Work Order ID 101946

Item Name: Crosstube Turning Detail

DRAWING NO. D412-664-243	TITLE CROSSTUBE ASS'Y (412 HI AFT)	REV. E	<b>DART AEROSPACE LTD ENGINEERING ORDER</b>		D.E.O. NO. D412-664-243-E-2	SHEET NO. SHEET 1 OF 1	SCALE NTS
DRAWN <i>q</i>	CHECKED <i>ASS</i>	MFG. APPR. <i>E 1</i>	APPROVED <i>MP</i>		DE APPR. <i>MP</i>		
DATE 11.09.07	DATE 11.09.19	DATE 11.09.19	DATE 11.09.19		DATE 11.09.19

DRAWING NO. D412-664-243	TITLE CROSSTUBE ASSEMBLY (412 HI AFT)	REV. E	DART AEROSPACE LTD ENGINEERING ORDER		D.E.O. NO. D412-664-243-E-4	SHEET NO. SHEET 1 OF 3	SCALE NTS
DRAWN 90	CHECKED A	MFG. APPR. A	APPROVED MP		DE APPR. MP		
DATE 12.08.21	DATE 12.08.30	DATE 12.08.30	DATE 12/8/30		DATE 12.08-30

**D412-664-243  
ASSEMBLY DETAIL**

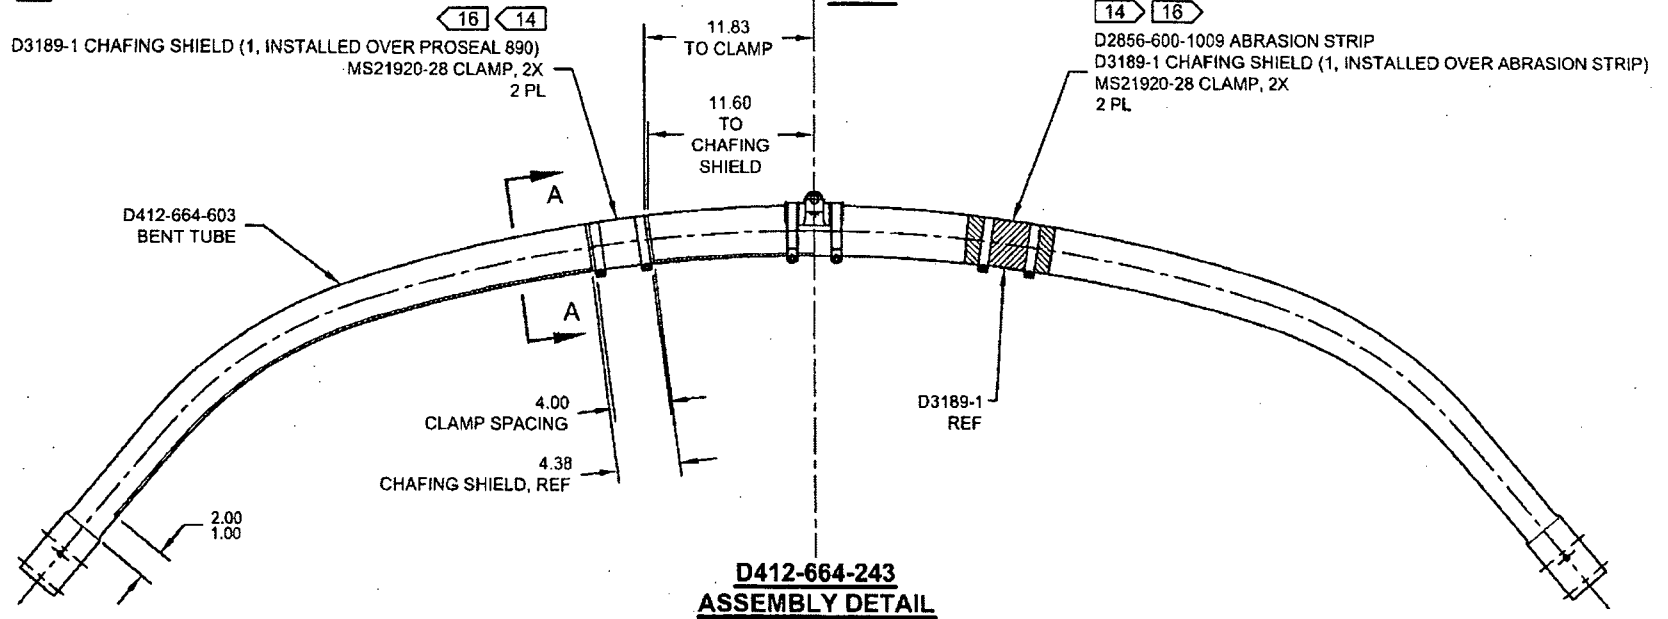
REMOVED ABRASION STRIP IN FAVOR OF A THIN LAYER OF PROSEAL 890. UPDATE INSTALLATION OF CHAFING SHIELDS AND REDUCE TORQUE TO 40-50 IN-LBS. THIS ENGINEERING ORDER SUPERCEDES DEO D412-664-243-E-1.

**IS:**

D3189-1 CHAFING SHIELD (1, INSTALLED OVER PROSEAL 890)  
MS21920-28 CLAMP, 2X  
2 PL

**WAS:**

D2856-600-1009 ABRASION STRIP  
D3189-1 CHAFING SHIELD (1, INSTALLED OVER ABRASION STRIP)  
MS21920-28 CLAMP, 2X  
2 PL
